To: T10 Technical Committee
From: John Worden (john.worden@seagate.com)
Date: 22 October 2002
Subject: 02-424r1 SAS Additional Port Layer Tweaks

This revision adds clarification and minor corrections to the SAS Port layer rewrite (02-393r1) [and corrects the header in revision 0](#). Changes include:

Figure 2. Port layer Overall Control (PL_OC) state machine

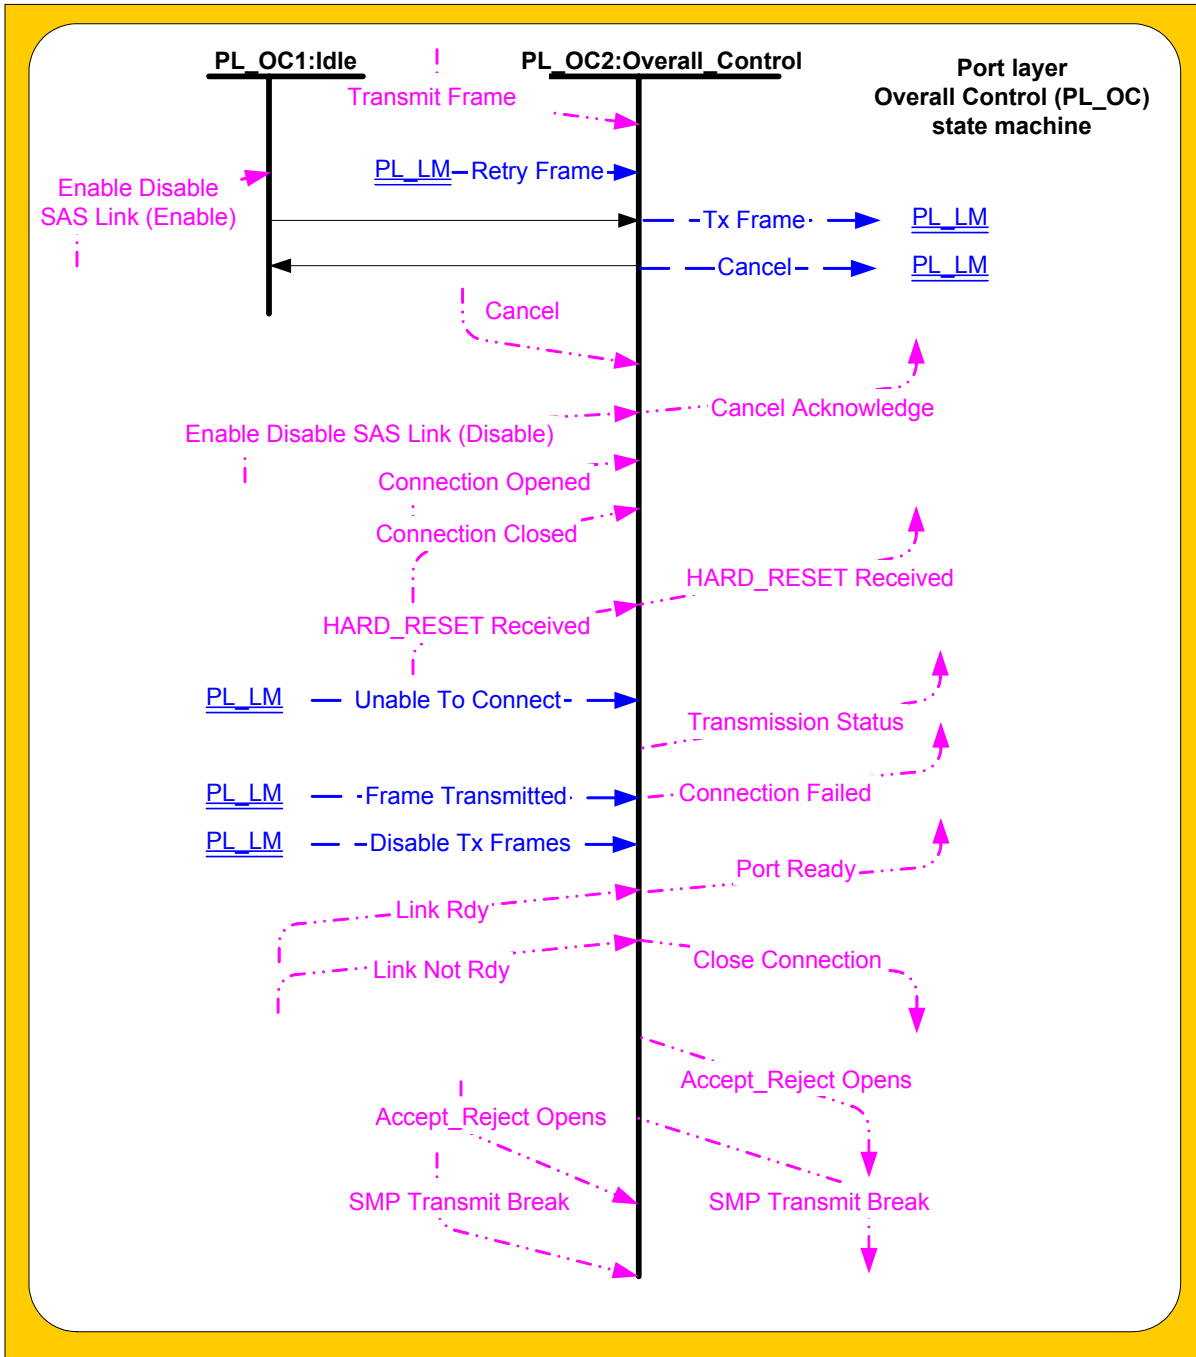
(Editors Note; Delete "Link Rdy " and "Link Not Rdy" from figure 2 ???)

Figure 3. Transmit Arguments

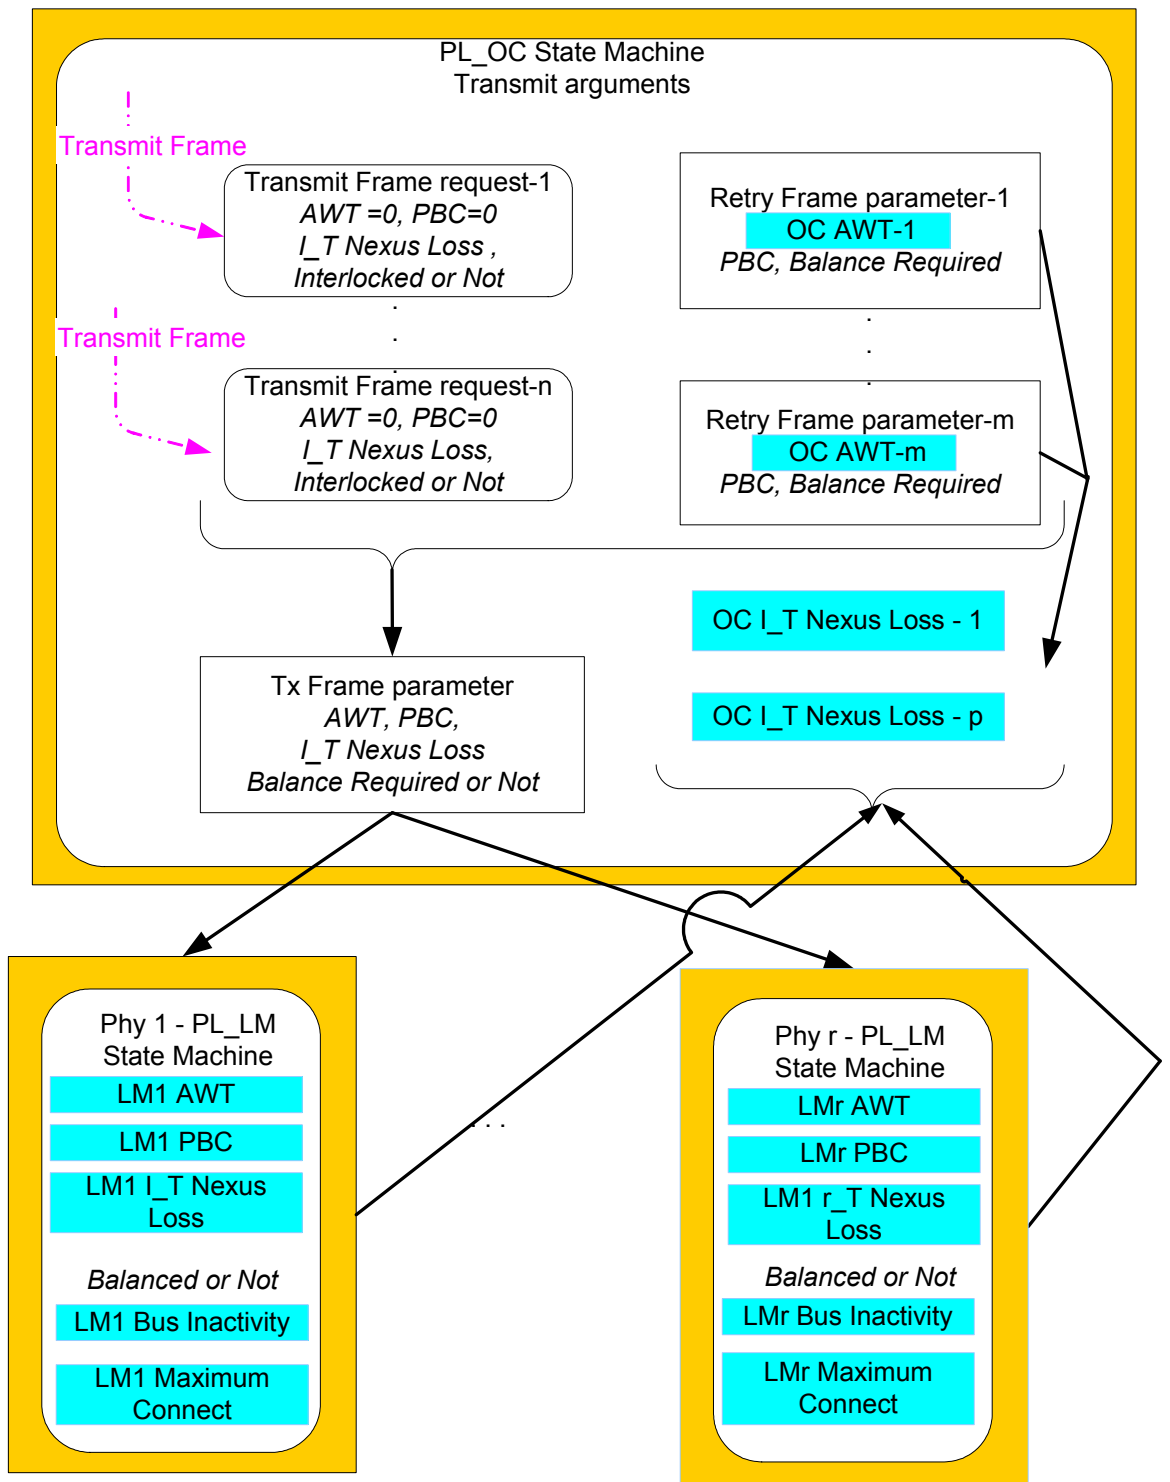
- a) Clarifies usage of the I_T nexus loss timer
- b) Adds the I_T nexus loss argument to the Transmit Frame request
- c) Adds Figure 3. Transmit Arguments plus explanatory text
- [d\)](#) Minor technical corrections and other clarifications

This state shall send a Tx Frame parameter to the PL_LM state machine corresponding to the selected phy carrying all the arguments from the selected Transmit Frame request or Retry Frame parameter unless otherwise noted in this specification. Figure 3 identifies transmit arguments passed between the PL_OC and PL_LM state machines. In Figure 3, Requests are in rectangular boxes with rounded corners and parameters are in rectangular boxes with square corners. Arguments are either in italics or shaded with light blue if from/to a counter or timer. The AWT, PBC, I_T nexus loss arguments for the PL_OC Tx Frame parameter are transferred to the selected PL_LM's AWT timer, PBC counter, and I_T nexus loss timer respectively. The AWT and PBC arguments for Transmit Frame requests are implied to be zero and are not received as arguments with the Transmit Frame request from the transport layer. The AWT and PBC arguments for the PL_OC Retry Frame parameters are obtained from the appropriate PL_LM AWT timer or PBC counter. The PL_OC Retry Frame AWT argument is stored in a timer which shall start incrementing if the AWT value received from the PL_LM state machine is non zero. If the value received is zero, the PL_OC AWT timer shall not start incrementing. The PL_OC Retry Frame parameter shall include a Balanced Required argument. The I_T nexus loss argument for the Tx Frame parameter is either ;

- a) obtained from the Transmit Frame request I_T nexus loss argument for Transmit Frame requests;
or
- b) obtained from the OC I_T nexus loss timer if a non zero timer value exists for this destination for
Retry parameters; or
- c) set to zero if no non zero OC I_T nexus loss timer exists for this destination for Retry parameters.

The current PL_LM I_T nexus loss timer value for a Transmit Frame request is sent to the transport layer as an argument in any Open Failed Transmission Status confirmation. For each destination, an OC I_T nexus loss timer is created from any non zero PL_LM I_T nexus loss timer value when an Unable To Connect parameter is received from the PL_LM state machine. This OC I_T nexus loss timer shall start incrementing from this non zero value. If the PL_LM I_T nexus loss timer value is zero when an Unable To Connect parameter is received, any existing OC I_T nexus loss timer to this destination shall be stopped incrementing and reset to zero.
